UNITED STATES PATENT AND TRADEMARK OFFICE

APPLICATION NO.	FILING DATE	FIRST NAMED INVENTOR	ATTORNEY DOCKET NO.	CONFIRMATION NO.
10/506,415	12/09/2004	Jan-Olof Svensson	P16012US2	8361
27045	7590	09/20/2006	EXAMINER	
ERICSSON INC. 6300 LEGACY DRIVE M/S EVR C11 PLANO, TX 75024			TIBBITS, PIA FLORENCE	
			ART UNIT	PAPER NUMBER
			2838

Office Action Summary

DETAILED ACTION

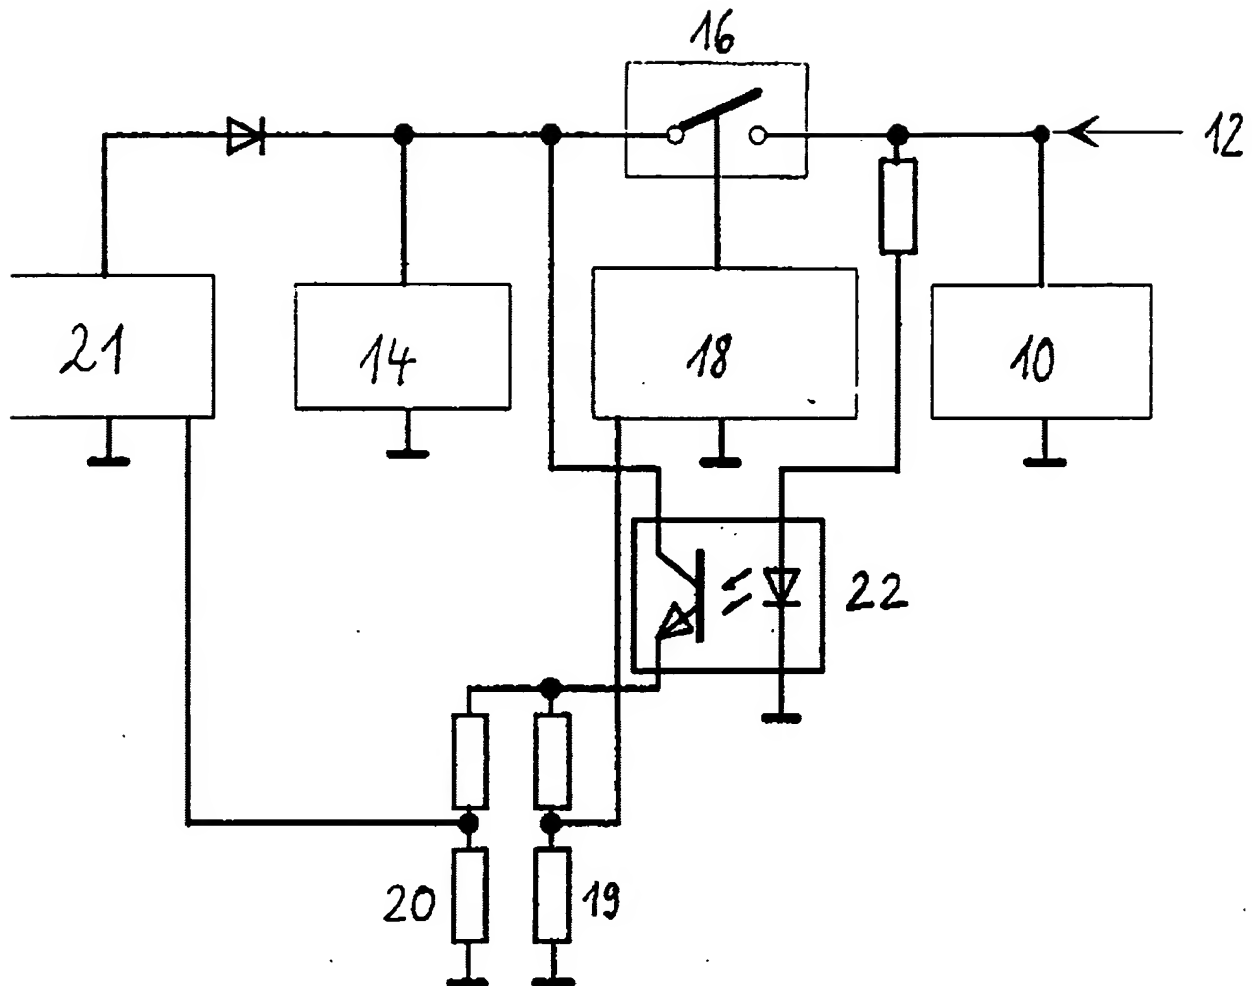
d) DE-19533537 also discloses in the abstract and in the figure:

The circuit protects a battery (14) provided for maintenance of supply to a load (10) after failure of the mains (12), which causes an electronic switch (16) to be closed by voltage monitoring and control logic (18). The deep-discharge measurement circuit and the battery-charging circuit are connected by an opto-coupler (22).

When the monitored voltage approaches the deep discharge limit, the switch is reopened and the load disconnected from the battery. The measuring and charging circuit voltage sensors (19,20) with the charge regulator (21) are also electrically isolated to prevent reconnection of the battery, which can occur only when the mains voltage is restored.

**FIGURE 5**

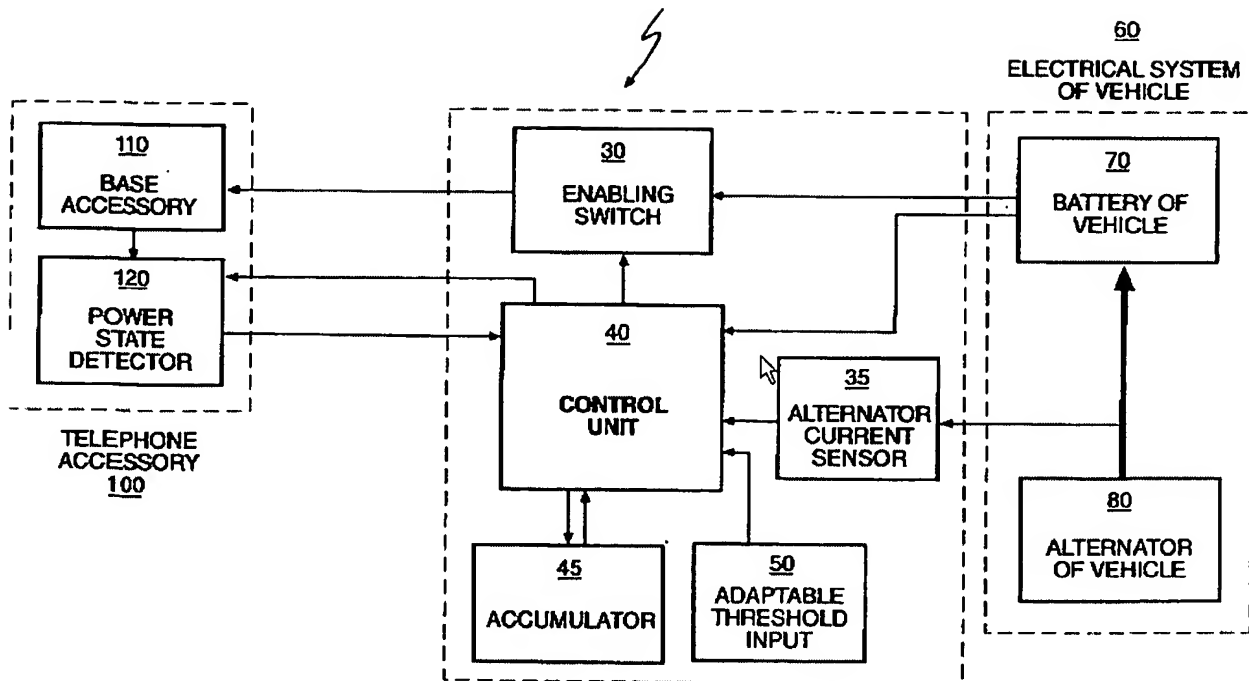
Irvin [5929604] discloses a battery-discharge-protection system for electronic accessories used in vehicles containing a battery so that when the total energy consumption meets or exceeds a threshold, the power to the battery-powered telephone device is interrupted in order to conserve a sufficient amount of power to start the vehicle and to operate other peripheral systems. This system includes an **"enabling switch"**:

FIG.3

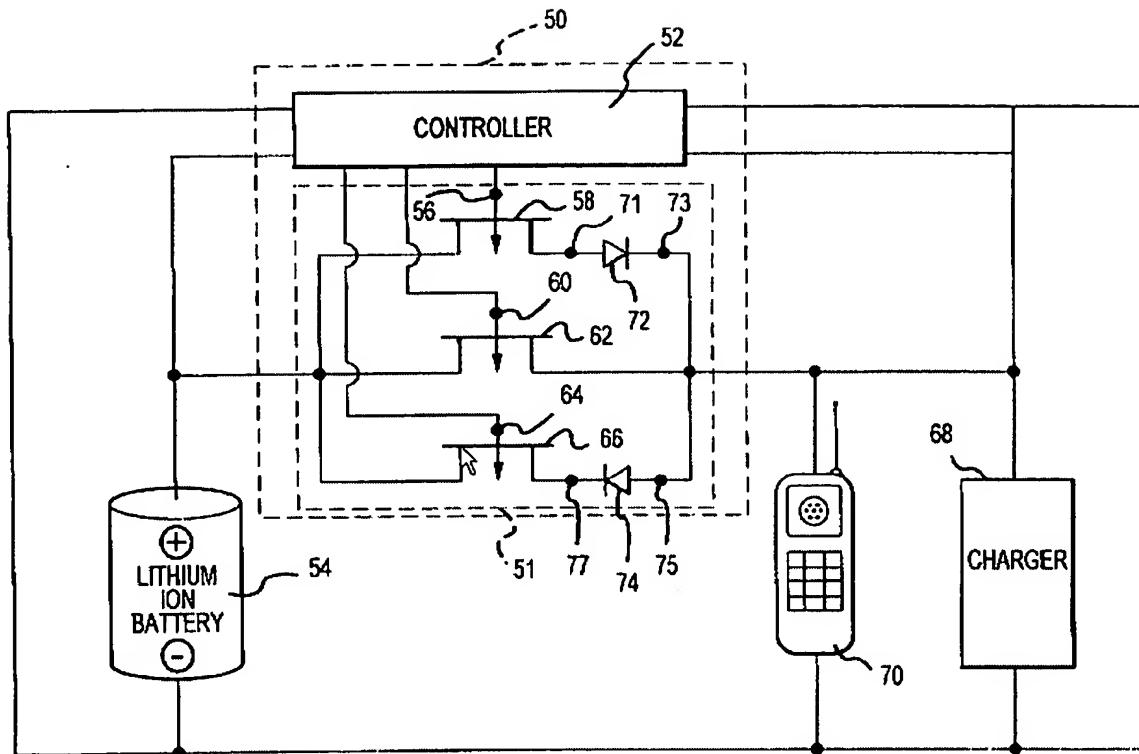
Colles et al. [5949218] discloses an apparatus for regulating the voltage potential of a lithium ion battery based upon an operating range having an upper threshold (e.g., on the order of 4.2 v) and a lower threshold (e.g., on the order of 2.5 v) and for providing a reduction in dissipated power when the lithium ion battery is charging and when a load is drawing upon the lithium ion battery:

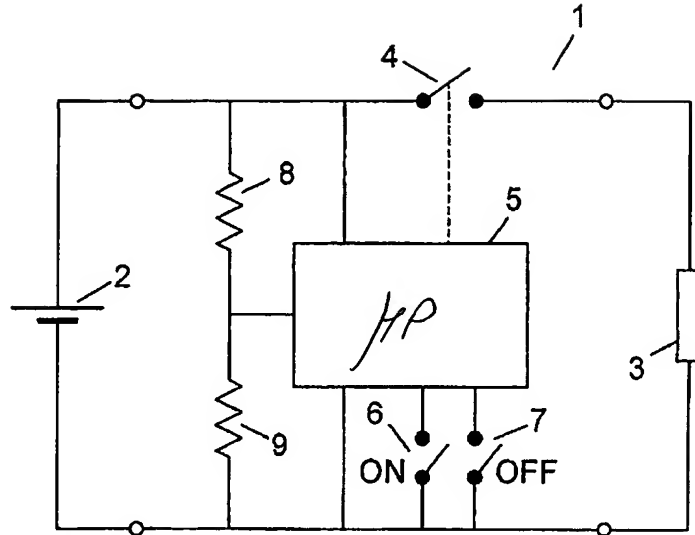
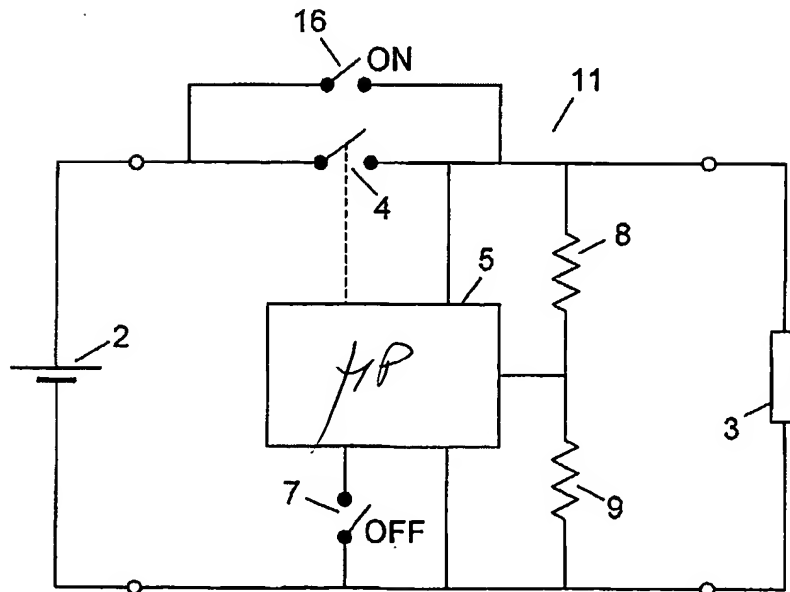
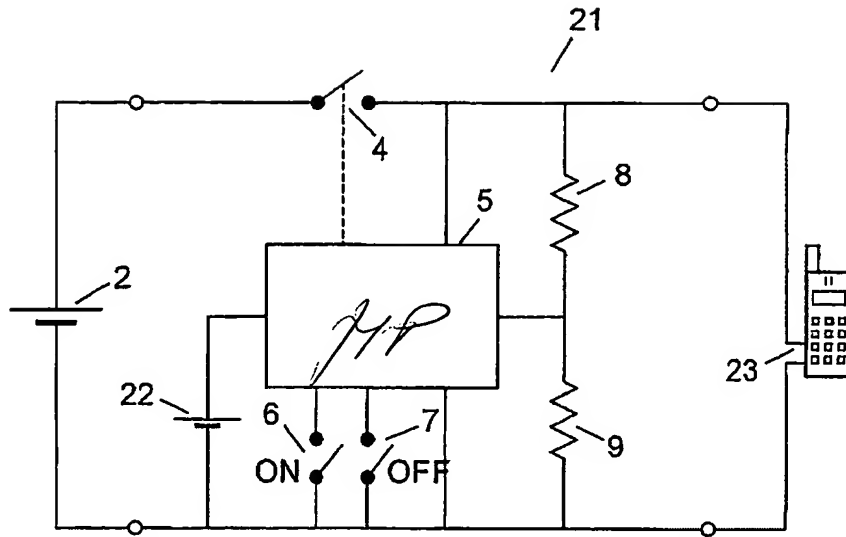
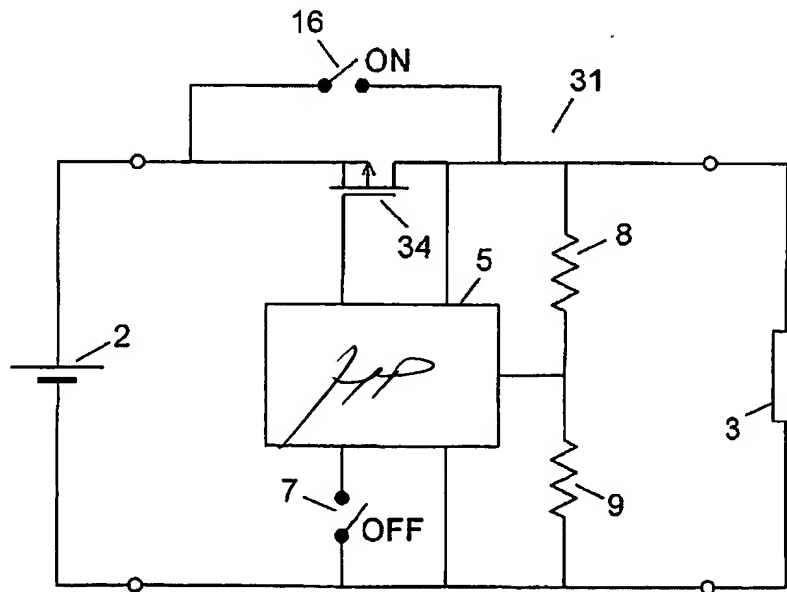
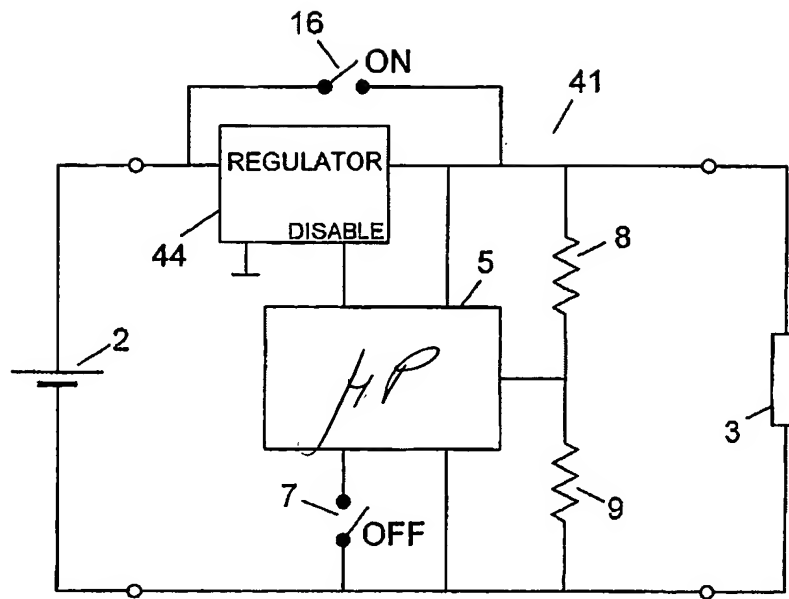
1. The drawings are objected to under 37 CFR 1.83(a). The drawings must show every feature of the invention specified in the claims. Therefore, the **microcontroller**, the **microprocessor** must be shown or the feature(s) canceled from the claim(s), as per attached. No new matter should be entered. Corrected drawing sheets in compliance with 37 CFR 1.121(d) are required in reply to the Office action to avoid abandonment of the application. Any amended replacement-drawing sheet should include all of the figures appearing on the immediate prior version of the sheet, even if only one figure is being amended. The figure or figure number of an amended drawing should not be labeled as "amended." If a drawing figure is to be canceled, the appropriate figure must be removed from the replacement sheet, and where necessary, the remaining figures must be renumbered and appropriate changes made to the brief description of the several views of the drawings for consistency. Additional replacement sheets may be necessary to show the renumbering of the remaining figures. Each drawing sheet submitted after the filing date of an application must be labeled in the top margin as either "Replacement Sheet" or "New Sheet" pursuant to 37 CFR 1.121(d). If the examiner does not accept the changes, the applicant will be notified and informed of any required corrective action in the next Office action. The objection to the drawings will not be held in abeyance.

a) 37 CFR 1.83(a) requires drawings to show the conventional names, as described in the specification, e.g. microprocessor, etc. for the elements shown in figures with non-conventional symbols.

APPROVED AS REVISED
9/10/06 DAB

APPROVED AS REVISED
9/10/06 PB

Approved as Revised
9/16/06
